# Summary of Comments and Responses

## Statewide Clean Water Act Section 303(d) List Portion of the 2024 California Integrated Report

Distribution date:  
January 4, 2024

**STATE WATER RESOURCES CONTROL BOARD**  
CALIFORNIA ENVIRONMENTAL PROTECTION AGENCY

**Figure 1:** Streamflow, in cfs, for USGS Gaging Station 11070500 (Canyon Lake Spillway) for the February 2017 Storm Event

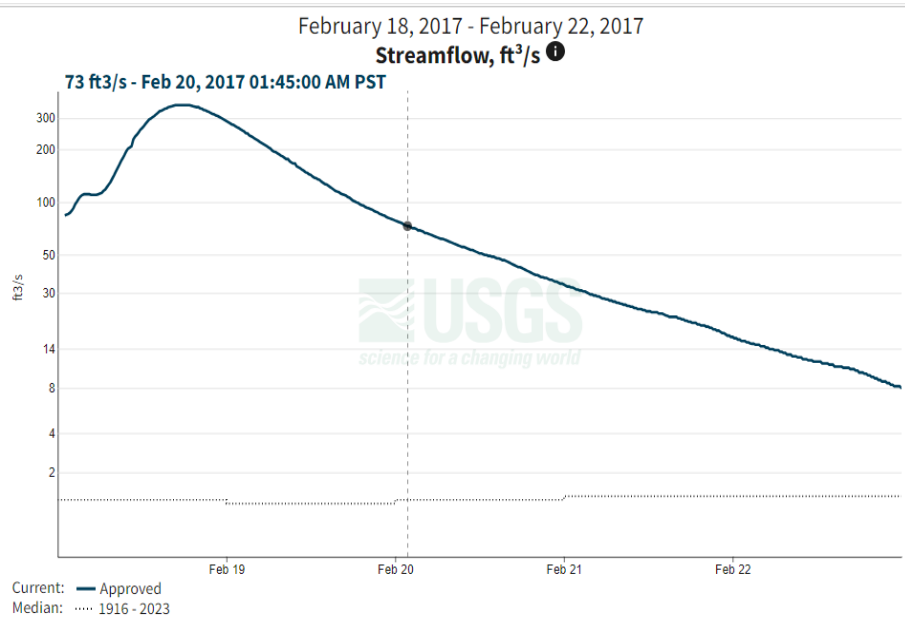
No.	Comment	Response
	<p>occurring and should not be the basis for determinations of impairment.</p>	<p>2017, and by the end of February 20, 2017, the flow decreased to 34.0 cfs.</p> <p>Figure 2, below, obtained from the Final Lake Elsinore and Canyon Lake Watersheds Nutrient TMDL Monitoring 2016-2017 Annual Report (Amec Foster Wheeler, 2017) shows the sampling conducted over the hydrograph for the February 17-20, 2017 storm event. One of those samples collected on February 20, 2017, was analyzed for total aluminum.</p> <p>There is only one other sample (LOE ID 307254) that exceeds the aluminum criterion for total aluminum and one exceedance is not sufficient to support a listing decision.</p>

024.07	<p>Accordingly, the evidence in the record indicates that there is no threat of impairment of the intermittent beneficial uses and that San Jacinto River Reach 1 should not be listed for aluminum.</p>	<p>Changes to listing recommendations were made in response to this comment. For more information, see response to comment 024.06.</p>
